ADDENDUM NO. 1

ISSUE DATE: **September 05, 2024**

RE: **CHAMBERLIN L&S SONGS PHYSICS LAB RENOVATION
UNIVERSITY OF WISCONSIN-MADISON
MADISON, WISCONSIN**

UW-Institution Project No. 0055-2346
UWSA Project No. A-23-012

5 NEW WORK PLAN - LEVEL 04 - COMPRESSOR ROOM 4278C
E301 SCALE: 3/8" = 1'-0"

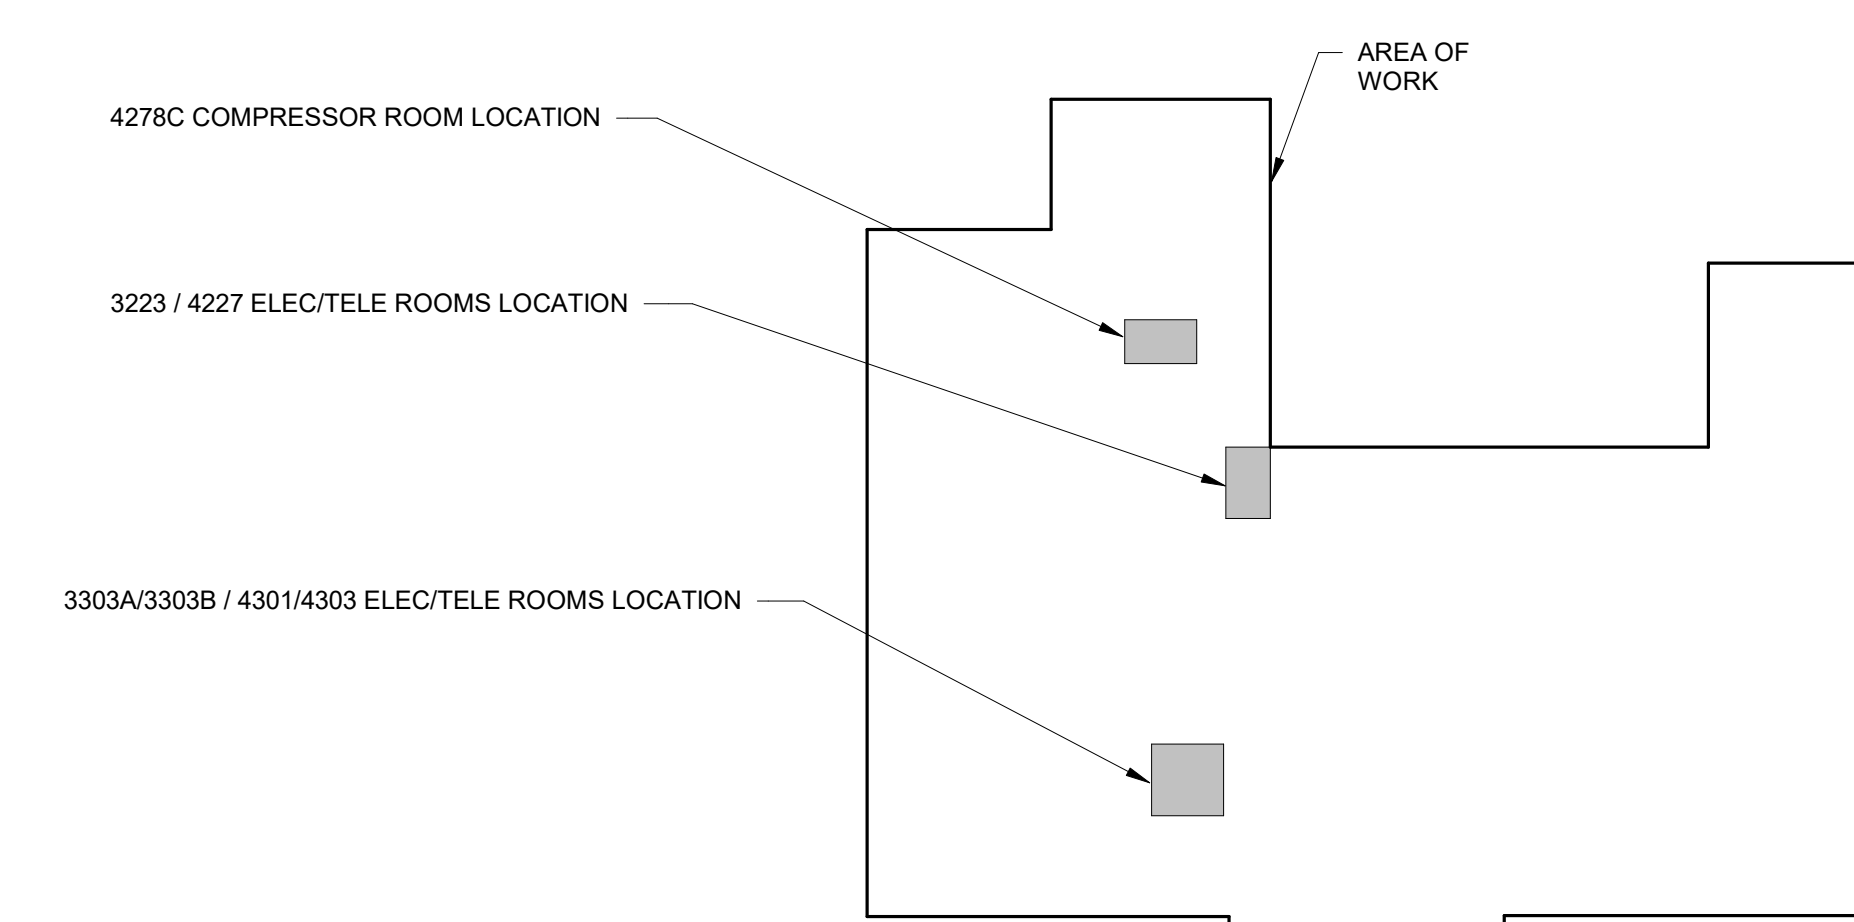
- 5. Sheet E301 – NEW WORK ENLARGED PLANS – LEVEL 03 & LEVEL 04 - ELECTRICAL
 - a. Revise power general note to clarify the number of current carrying conductors allowed to be installed in a single conduit prior to conductor derating.

- REFER TO SHEET E000 FOR ALL SYMBOLS, ABBREVIATIONS, AND DETAILS.
- THE CONTRACTOR MAY INSTALL UP TO THREE (3) CURRENT CARRYING CONDUCTORS IN A CONDUIT. WHEN UTILIZING ONLY #12 CONDUCTORS, THE CONTRACTOR MAY INSTALL UP TO SIX (6) CURRENT CARRYING CONDUCTORS IN A CONDUIT. LOADINGS ARE BASED ON THWN INSULATION, 40°C AMBIENT WITH DERATINGS FOR TEMPERATURE AND UP TO THREE (3) CONDUCTORS IN A CONDUIT. CONTACT THE ENGINEER FOR WIRING IN OTHER CONDITIONS TO ACCOUNT FOR CONDUCTOR DERATING. NEUTRAL CONDUCTOR SHALL BE CONSIDERED A CURRENT CARRYING CONDUCTOR IN UNBALANCED, 3-PHASE APPLICATIONS.
